Landscape Consultation

Proposal: Discharge of conditions 6 (landscaping), 8 (archaeology), 9 (foul and surface water), 10 (biodiversity enhancements) and 15 (bin and bike stores) of 22/00793/FUL	**Location:** Stonely House 37 - 41 Main Road Stonely
Case Officer: HHOD **Landscape Officer:** PBAI	**Application No:** 25/80051/COND

- Proposed Hard and Soft Landscaping Plan S667-DC-01B

MIXED NATIVE HEDGEROW PLANTING DETAIL - 5/m
Double staggered row with 800mm trench
Not to Scale

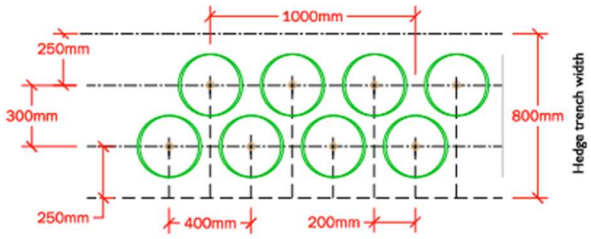
Landscape maintenance regimes *(iii.)* and an implementation programme *(iv.)* are shown on the dwg. This should also include details of the double staggered mixed native hedgerows on future amended plans, which is further recommended.

It is further recommended that the proposed laurel hedge to the frontage of the new dwelling is replaced with a mixed native hedgerow. Is it also recommended that a mixed native hedgerow is provided along the western boundary of both plots to supplement the post and rail fence given the adjacent countryside location.

The hedge shall be planted in a staggered row at the above dimensions

Most accepted form of native mixed hedge planting.

A 75mm deep layer of bark mulch must be provided across the hedge trench width along the length of the hedgerow.
